**RESPONSES TO NYSDEC COMMENTS ON THE LTEV OPERATIONS PLAN  
AND THE LTEV TESTING PLAN - FOR SUBMITTAL TO USACOE**

**Operations Plan:**

### **Performance Testing Plan**

**SPECIFICATIONS FOR LTEVS DUST CONTAINMENT STRUCTURE**

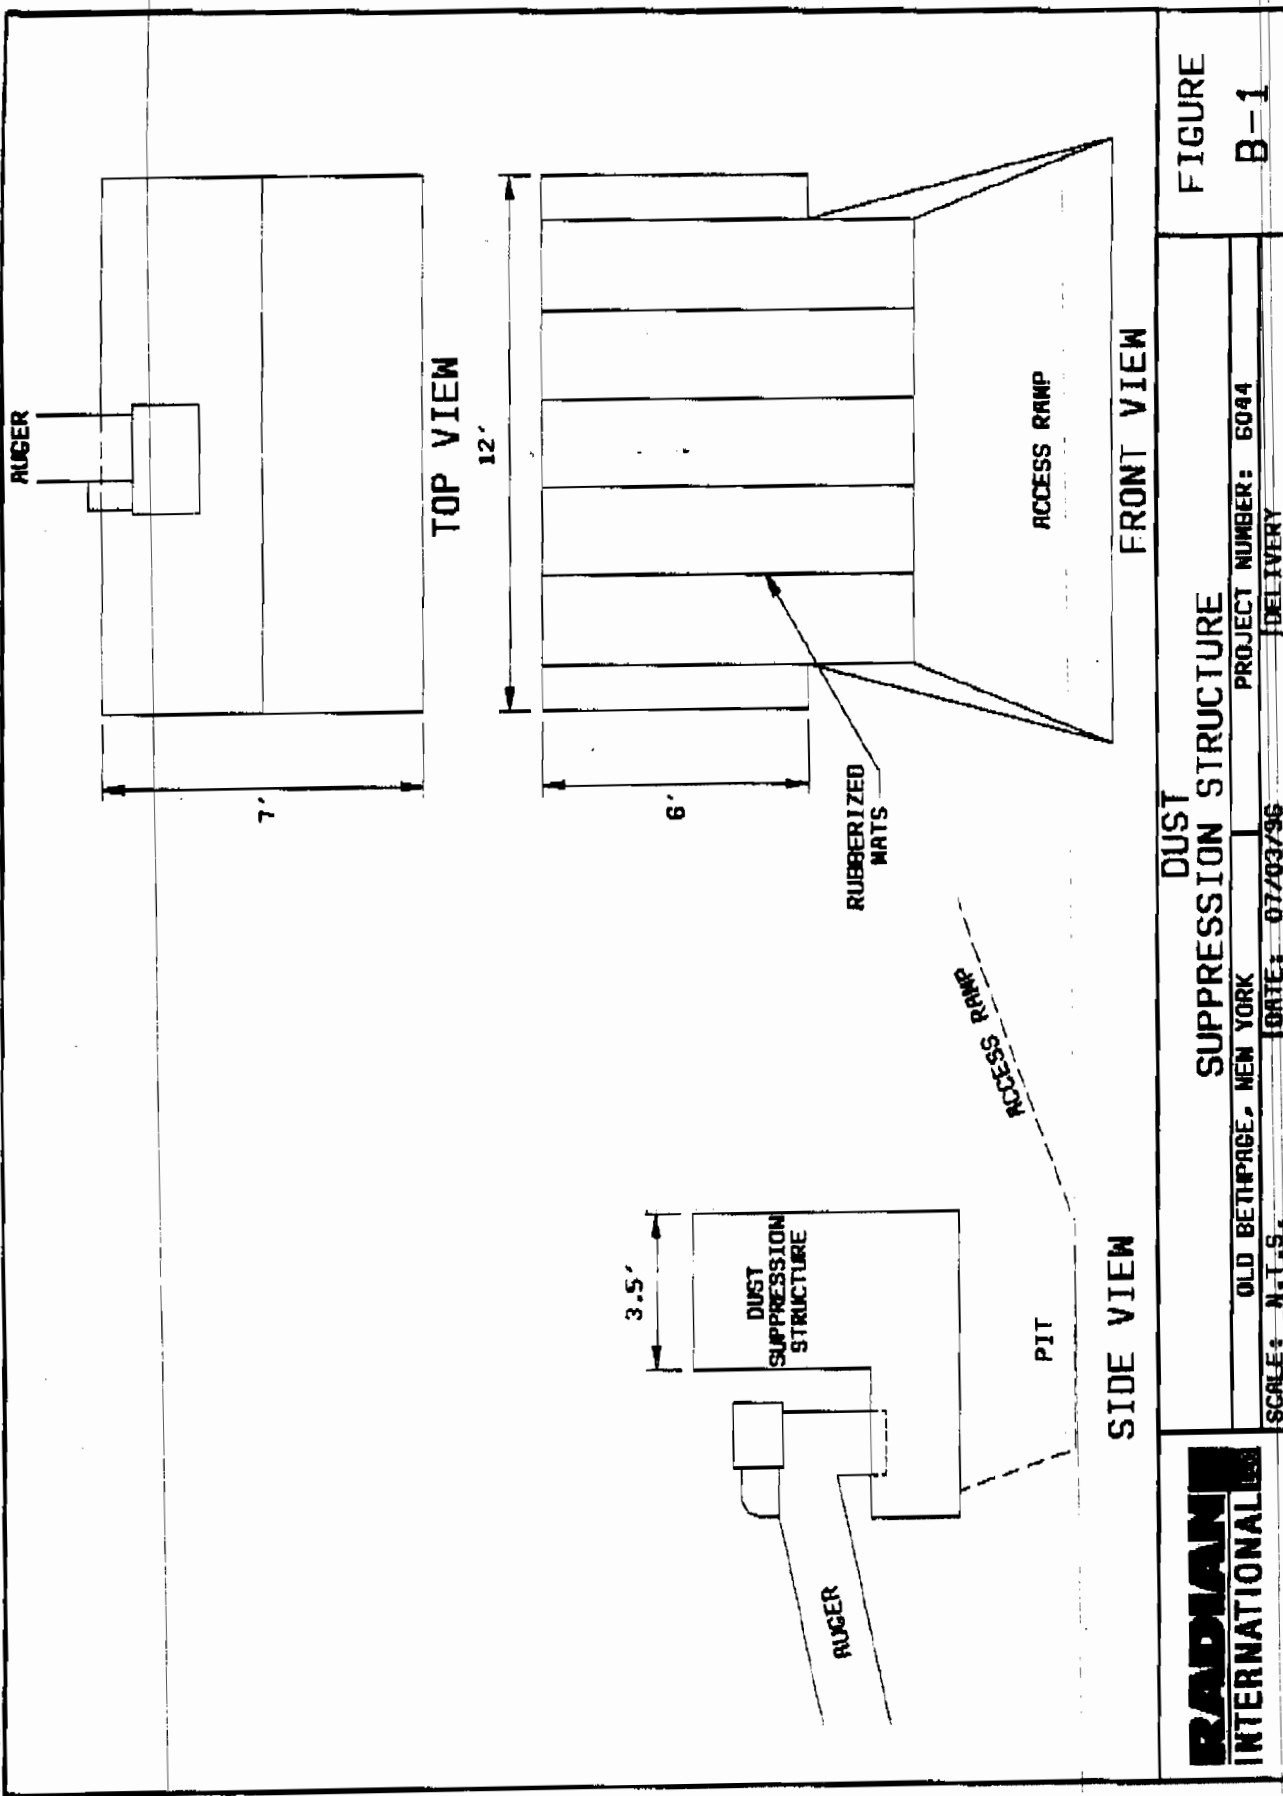
*COMMENT 5. Based on experience with other low temperature thermal desorber units, the Department strongly recommends an enclosure around the discharge conveyor. Fugitive dust from treated soil has been a problem on other sites. The contractor should submit the specifications on these enclosures to the USACOE for approval. If fugitive dust is a problem, these enclosures must be implemented without delay (Section 1.4.2.g, page 1-4).*

**RESPONSE:** Section 1.4.2.g has been revised as follows: "Construct a temporary dust suppression housing around the exit port on the discharge moisturizing auger (specifications for the dust suppression structure appear in Appendix B). A temporary enclosure may also be placed around the control panels located at the ends of the trailers of considered necessary;" See Attachment A, herewith, for a copy of Appendix B which has been added to the Plan Appendices. Appendix B has also been added to the List of Appendices. The specifications in Attachment A for the dust containment structure are, hereby, submitted to the USACOE for approval.

A temporary dust containment/suppression structure will be constructed around the exit port of the discharge moisturizing auger and over a pit with a sloping access ramp. The pit will slope from one end to allow a loader to enter and will have a near vertical back wall to push against when picking up stockpiled soils. At its deepest point the pit will be about 2.5 to 4.0 ft deep, depending on the nature of the terrain and loader access requirements. The dimensions of this structure will be approximately 12 ft wide by 7 ft deep by 6 ft high. The structure will be constructed of 3/8" plywood with 4"x4" support legs and beams and with 2"x4" nailers. A drawing of the structure appears below in Figure A-1 of this Appendix. Fiberglass insulation will be used to insulate and seal the opening where the auger enters the dust suppression structure. Rubberized sheeting or matting (or equivalent) will be hung in strips across the front of the structure to retain dust and still allow a loader bucket to pick up remoisturized soils stockpiled within the structure.

A minimum of 12 high pressure water spray nozzles will be located inside of the dust suppression structure along the top and oriented to produce a fog barrier to inhibit dust from exiting the structure. These nozzles are part of a fog system designed to suppress ultra-fine dust which may be found in the treated soils. The system consists of a high pressure pump module, an atomization line, a manifold line, atomizing nozzles and plugs and auto drain valves.
